# 2020 Corvette: GM TechLink: Front Fender and Fascia Realignment

## 2020 Corvette: Front Fender and Fascia Realignment

June 16, 2020  
GM TechLink

Fig. 12

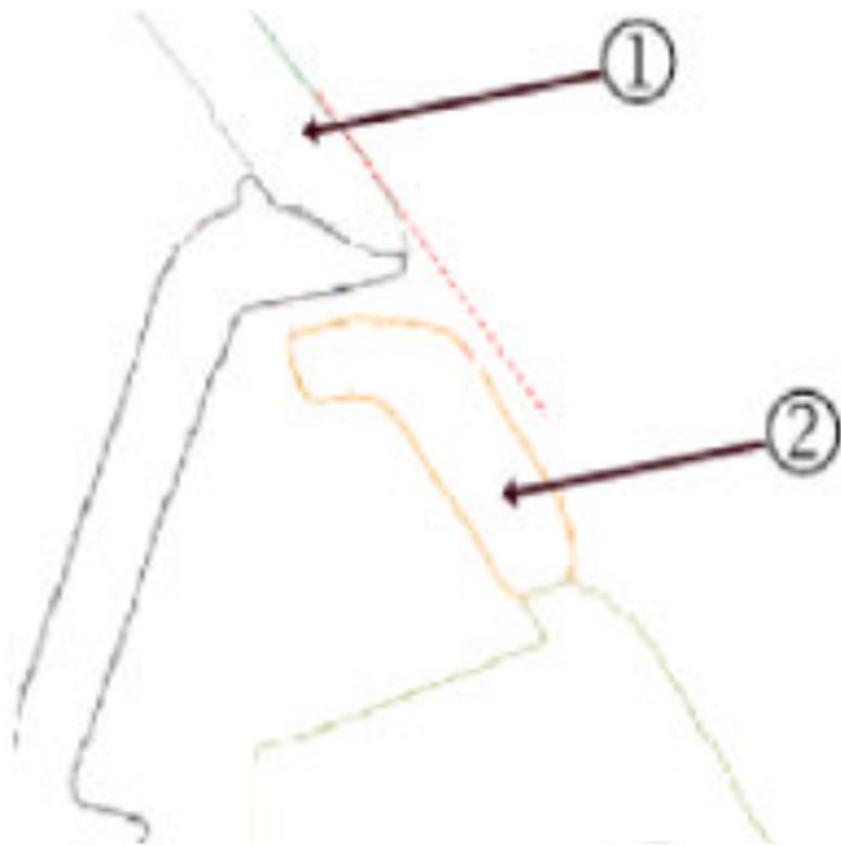
After adjusting the fender inboard, the headlamp lens (Fig. 12, #1) will be proud of the fender (Fig. 12, #2) and the fascia tip will install below the headlamp lens. (Fig. 13)

Follow the realignment procedure in Bulletin #20-NA-124. The front tire and wheel assembly, front wheelhouse liner and front wheel opening molding must be removed on the affected side of the vehicle.

Refer to Bulletin #20-NA-124 for complete instructions and additional information.
